Reactor Oversight Process Task Force FAQ Log – June 26, 2013

FAQ Log Entering ROP Public Meeting on June 26, 2013

NRC Final Response
FAQ 12-04, HRA Related Occurrences (Generic)

FAQ 13-01
Turkey Point Unplanned Scrams per 7000 Hours Critical

U1C18 BOC Startup Load Profile

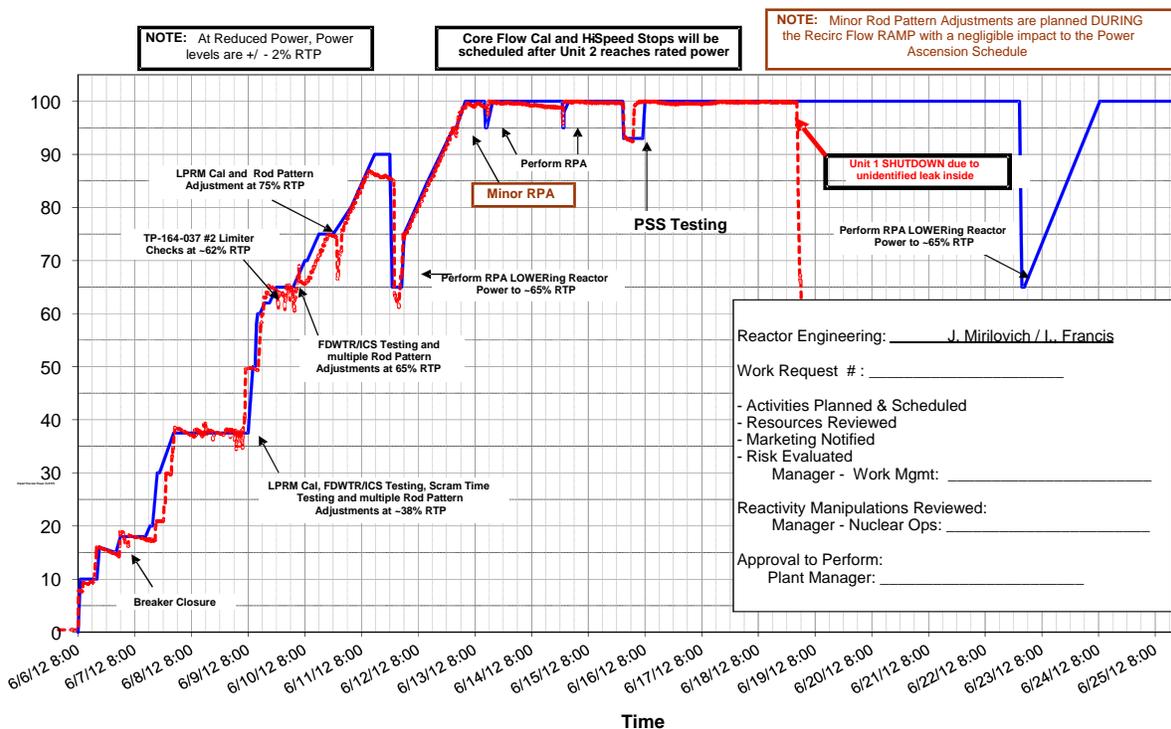
Susquehanna Unit 1 was in the process of reducing power on 6/11/2014, at 21:35, for a planned rod pattern adjustment. See the load profile below for a comparison of the predicted power changes in blue and the actual power changes in red.

C) The inspectors questioned PPL’s basis for not counting the downpower as unplanned. This is based on A(3) above in that the power reduction was not implemented as planned. Specifically, PPL’s planned power reduction had not included a recirculation runback as part of the downpower sequence, was an interruption of the rod pattern adjustment, and was completed “more rapidly than originally projected.” The resident inspectors also considered the runback a

The resolution to this event should be to conclude that it should not be reported as an unplanned power change per 7000 critical hours. Propose adding clarification to Page 14, Lines 10-14 as follows: "Problems encountered during a planned power reduction greater than 20% that alone may have required a power reduction of 20% or more to repair are not counted as part of this indicator if they are repaired during the planned power reduction. However, if during the implementation of a planned power reduction, power is reduced by more than 20% of full power beyond the planned reduction, then an unplanned power change has occurred."
